ATTACHMENT B

Evaluation of Recirculated Draft Environmental Impact Report on Geological Storage of Carbon Dioxide at the Carbon TerraVault I Facility in Kern County, California

Dominic DiGiulio, Ph.D.

July 16, 2024

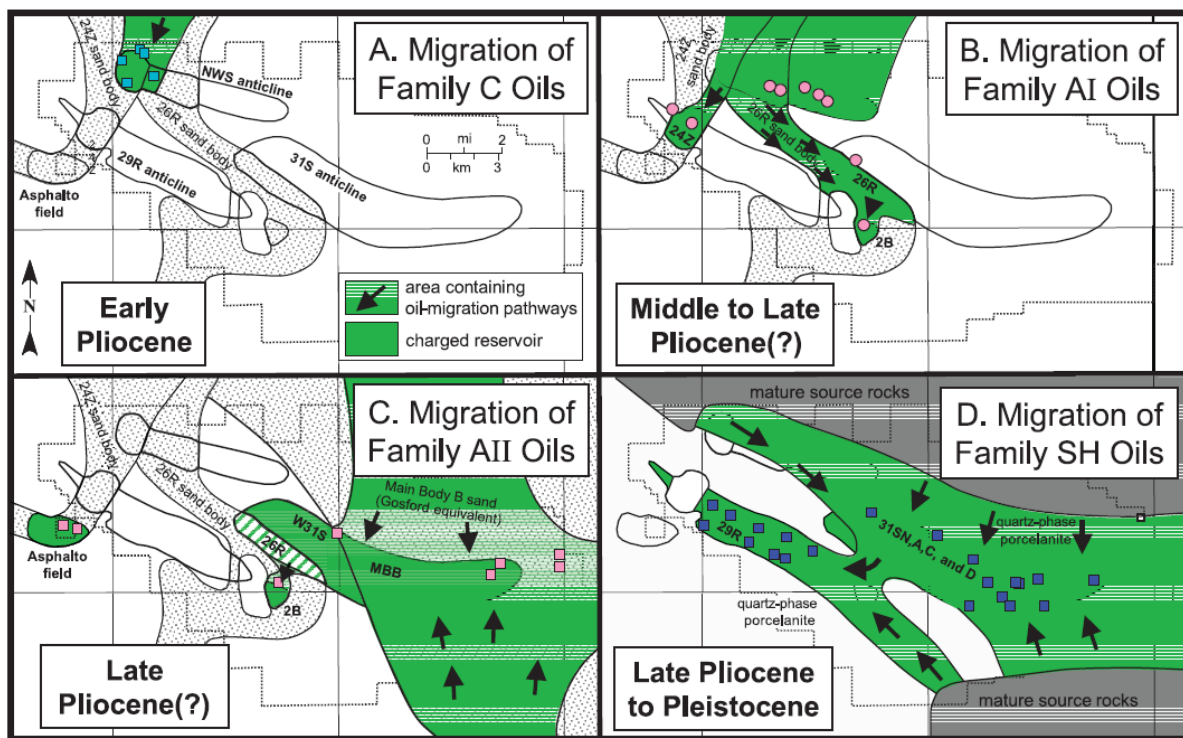
Comment: The isolation of injected CO₂ in anticlinal structures is of concern. In Volume II of the recirculated DEIR (RDEIR, 2024b), CTV states that the Monterey Formation in the 26R and A1 - A2 storage reservoirs have “*minimal*” connection outside the Area of Review. The DEIR is vague about what this means for the project and lacks support for this assumption. Do anticlinal structures provide full containment or not? The 26R Reservoir is located within the 26R sands of the 31S anticline while the A1 - A2 reservoir is located in the western portion of the Northwest Stevens (NWS) anticline. As discussed by Zumberge et al. (2005), the Northwest Stevens anticline and the 29R anticline share some of the same turbidite sand bodies (24Z and 26R sand bodies) (Figure 1). Also, the Northwest Stevens anticline shares the 26R sand body with the 31A anticline (Figure 1). After filling of the Northwest Stevens anticline reservoirs, oil appears to have spilled into and filled the 24Z trap (Figure 1). This same oil family may also have reached the 2B trap on the east nose of the 29R anticline and the 26R reservoir at the west end of the 31S anticline (Figure 1), again moving within turbidite sand bodies from the Northwest Stevens

(NWS) structure. It appears then that there is hydraulic communication between the Monterey Formation inside and outside of the 26R and A1 - A2 reservoirs and injection must be carefully managed to avoid migration of injected CO₂ outside of these reservoirs (exceedance of spill point). From schematics provided by CTV, there are a large number of wellbores screened in the Monterey Formation outside of storage areas (Figure 2). At least some of these wellbores should be converted to monitoring wells to monitor for both pressure perturbation and CO₂ leakage during injection.

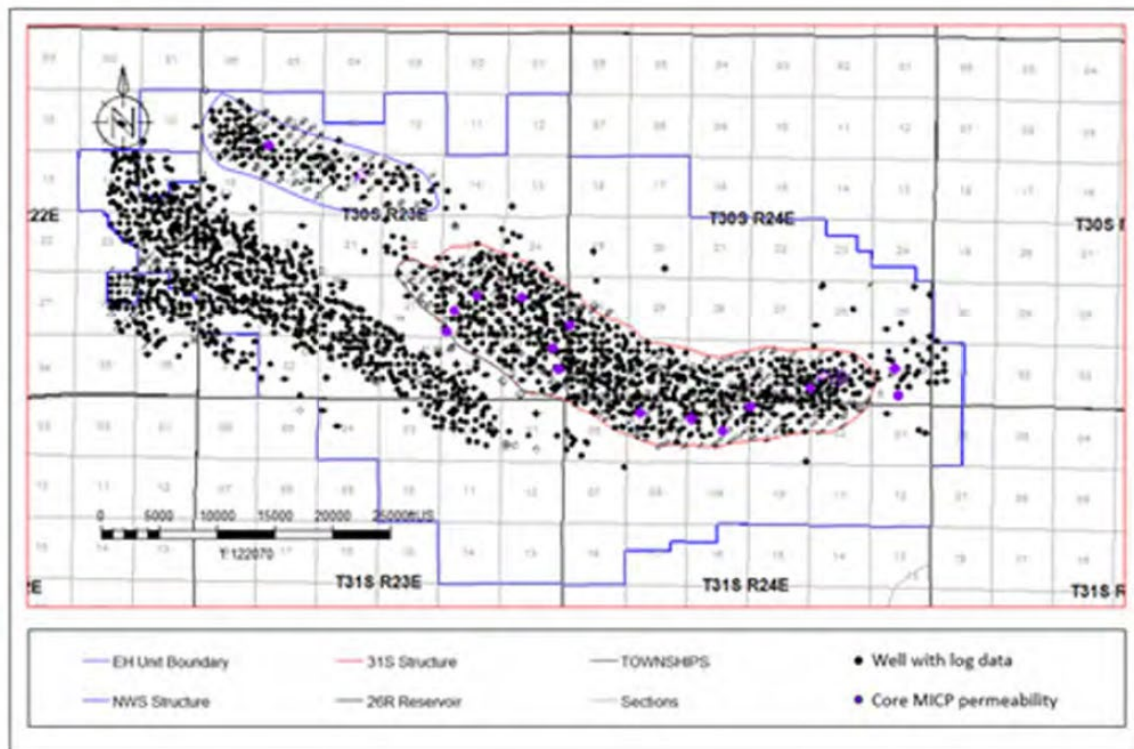
Comment: In Volume II of the recirculated DEIR (RDEIR, 2024b), CTV states that confinement of the Reef Ridge Shale has been demonstrated in the 26R reservoir by the injection of 841 billion cubic feet of gas and 114 million barrels of water with no leakage. CTV states that confinement of the Reef Ridge Shale has been demonstrated in the A1 - A2 reservoir by the injection of 175 billion cubic feet of gas and five million barrels of water with no leakage. Referring to the work by Zumberge et al. (2005), CTV further states that geochemical analysis of reservoirs confirms compartmentalization through several million years and effectiveness of the Reef Ridge Shale to contain the CO₂ injectate (RDEIR, 2024b). However, as discussed in the previous comment, this geochemical analysis also confirmed migration of oil between anticlinal traps, which the DEIR does not discuss. More importantly, there is no evidence of how and if leakage was monitored. It does not appear that CRC used monitoring wells in the Monterey Formation outside the 26R and A1 - A2 reservoir areas to evaluate migration of injected fluids beyond anticlinal structures associated with these formations. It also does not appear that CRC monitored oil and gas wells for gas leakage during enhanced oil recovery operations. Hence, the veracity of these claims cannot be independently verified, and they are not supported by arguments provided. Again, CTV should

convert several existing oil and gas wells screened in the Monterey Formation outside storage reservoirs into additional monitoring wells.

Figure 3. Simulation of 10% pressure loss per year, 0.1% pressure loss per year, and 0.01% pressure loss per year for 1000 years starting at 4000 psi.

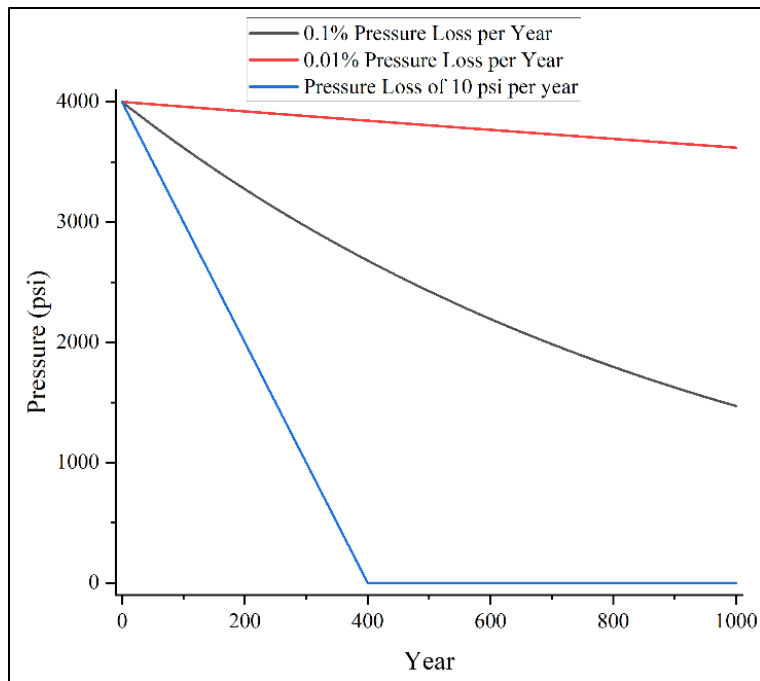
A pressure loss of 10 psi per year is not negligible. A simple back of the envelope calculation indicates that a pressure loss of 10 psi per year starting at 4000 psi (final target pressure) results in complete pressure loss in 400 years (Figure 3) resulting in appreciable CO₂ loss. In reality, the rate of pressure loss will decrease somewhat as pressure decreases in the formation (i.e., reduction in driving force) as illustrated in loss in percent per year (Figure 3). This metric of leakage verification is not sufficiently protective and should be rejected. A target of 0.01% pressure loss per year is more reasonable if permanent storage of CO₂ is actually the goal of this project.

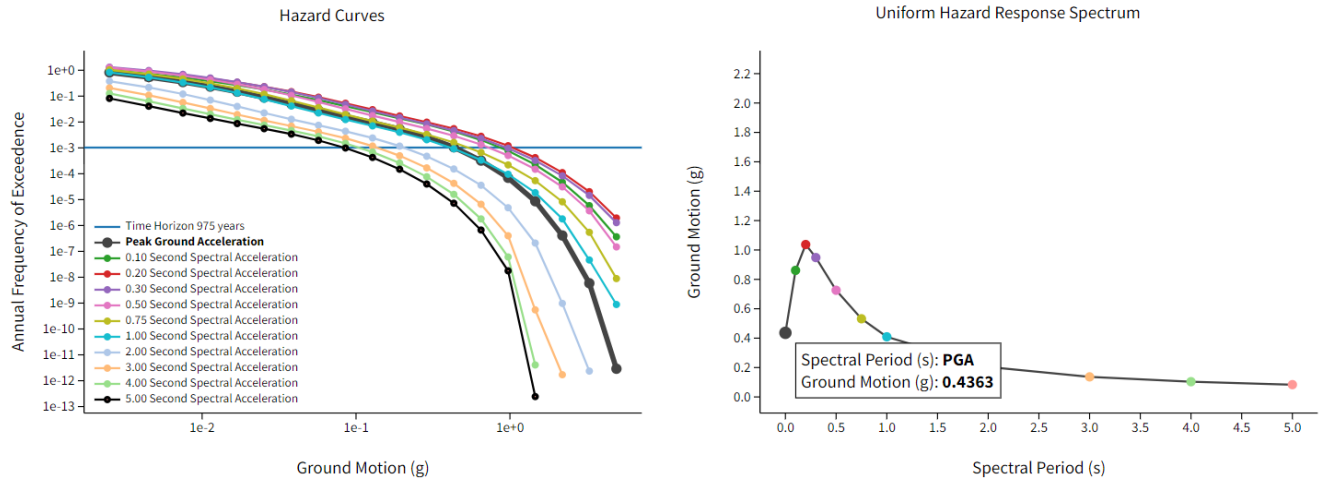
For the project location, a peak ground acceleration rate of 0.4363g was estimated having a 5% probability of exceedance in 50 years with an annual rate of exceedance = 1.025E-03 or a return period of 475 years (RDEIR, 2024b). The return period or time horizon is the inverse of the annual rate of exceedance. Using the USGS “rule of thumb” for calculating return period, this is approximately equivalent to a 9.8% probability of exceedance in 100 years, a 42% probability of exceedance in 500 years, and a 69% probability of exceedance in 900 years. A further examination of the hazard curves

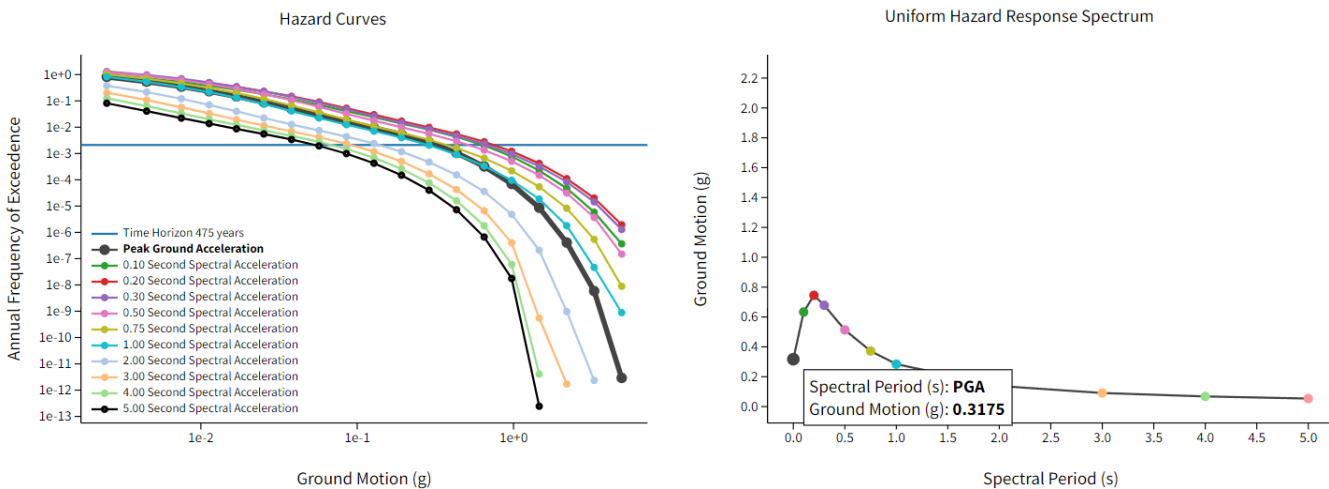
(Figure 8) (not included in the recirculated DEIR) indicates a peak ground acceleration of 0.3175g having a 10% probability of exceedance in 50 years, 19% probability in 100 years and a 64% probability of exceedance in 400 years. Care was taken in these calculations to ensure that $r^* \leq 1$ where $r^* = r(1+0.5r)$ and r = probability as recommended by USGS (USGS, 2024).

Figure 9. Schematic representation of pressure migration along a high-permeability fault between the Tejon Oil Field and a M 4.6 seismic event along the White Wolf Fault.

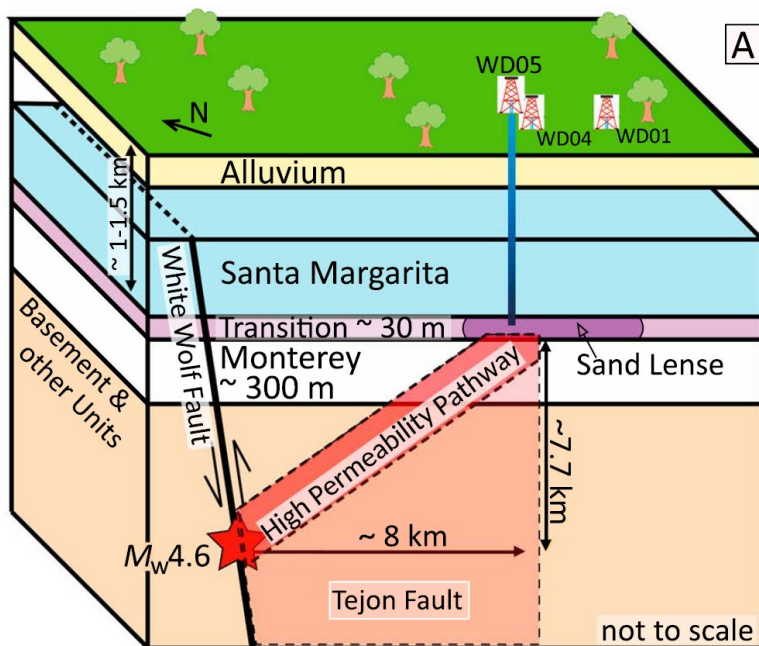
Comment: For induced seismicity, the primary concern here is pressure transmission below the Monterey Formation, not above it. In the Class VI regulations, the primary concern is leakage through faults in the confining layer, not transmission of pressure and induced seismicity below the storage formation. Hence, neither EPA regulations nor the recirculated DEIR adequately consider induced seismicity. Callas et al. (2022) state that lack of a lower confining seal (permeability > 100 nanodarcy) is a disqualifying threshold for geologic storage of CO₂ because of potential pressure propagation to basement rock capable of producing seismic activity. According to schematics provided in Volume II of the recirculated DEIR (RDEIR, 2024b), the Reef Ridge Shale bounds both the upper lower Monterey Formation and has an average permeability of 0.01 millidarcy or 10,000 nanodarcy. As discussed, in the 26R and A1 - A2 Storage Areas, CTV states that final pressure will target the initial reservoir pressure at the time of discovery. Hence, this would decrease but not eliminate the possibility of induced seismicity.
